Service Instruction

ENGINE COMPONENTS, INC.

S.I. No.: 05-9

Title: REWORK OF TCM CONNECTING RODS FOR BOLTS WITH CONTOUR HEADS

Figure 1

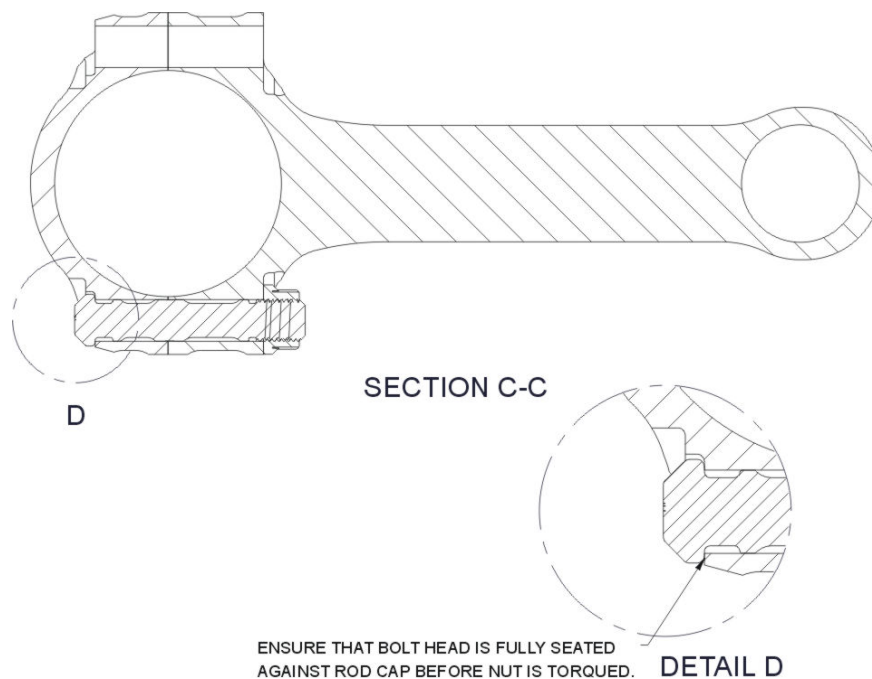
- 6.4 **Inspect:** Visually inspect each bolt head to ensure that it is fully and properly seated in the machined recess of the connecting rod cap. See Figure 1 below.

- 6.5 **Initial Torque:** Tighten both nuts on each rod to an initial torque value of 350 in/lb (29.2 ft/lb). Again inspect bolt heads for proper seating. See Figure 1 below.
